ADDENDUM NO. 8

PROJECT NO. DGS C-0948-0090 PHASE 003

**PROJECT TITLE - Capitol Complex Central Plant - Building Renovations, Chiller System
Replacement and Electrical System Upgrades**

H.F. Lenz Co.

1 SITE LOGISTICS AND PROJECT SEQUENCING PLAN
Scale: 1"=30'-0"

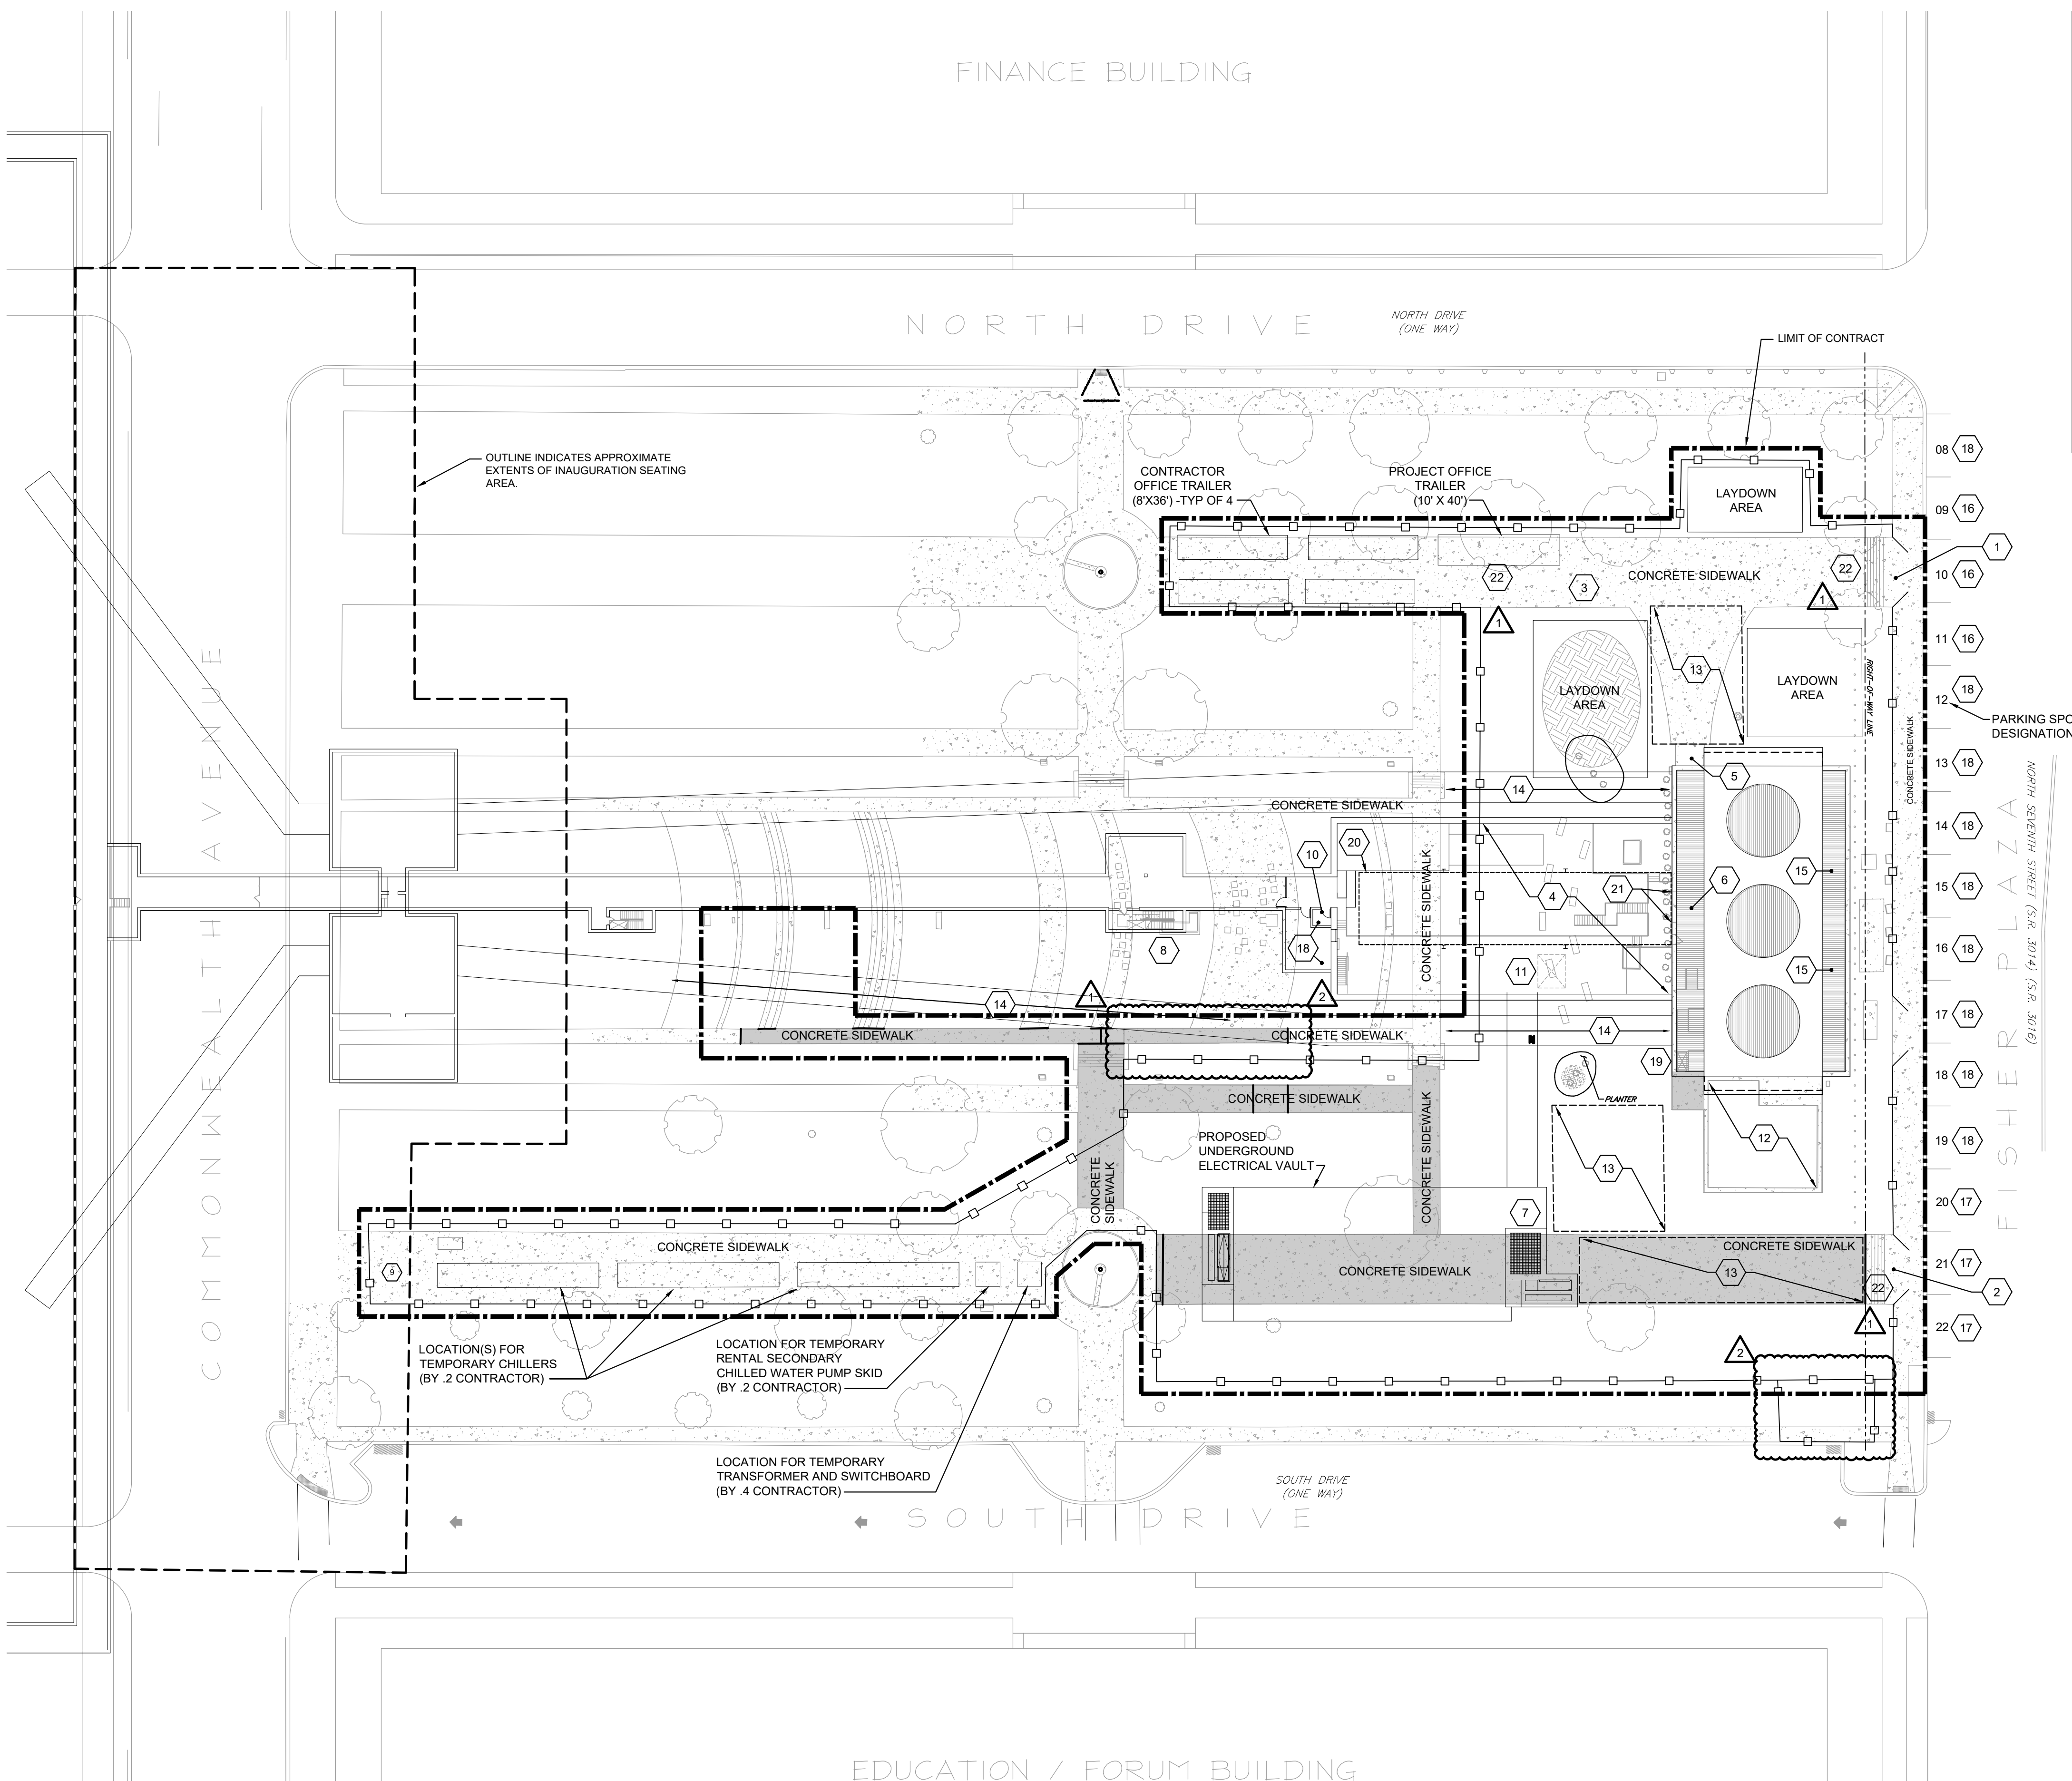
Item 3 - Section 010250, Article 1.7, Paragraph A, add sub-paragraph # 9 "Unit Price 9: Heavy Concrete Sidewalk scope of work as identified on drawings C101 and G002 and Specification Section 321313 "Concrete Paving".

- THE LEAD CONTRACTOR SHALL REPAIR OR REMOVE AND REPLACE, AS REQUIRED, ANY DAMAGES CAUSED BY CONSTRUCTION TO THE SIDEWALK WITHIN THE LIMITS OF CONSTRUCTION AND THE STAIRS AT THE VEHICULAR ACCESS LOCATIONS. PROVIDE UNIT PRICE FOR HEAVY CONCRETE SIDEWALK IN ACCORDANCE WITH SPECIFICATION 010500.
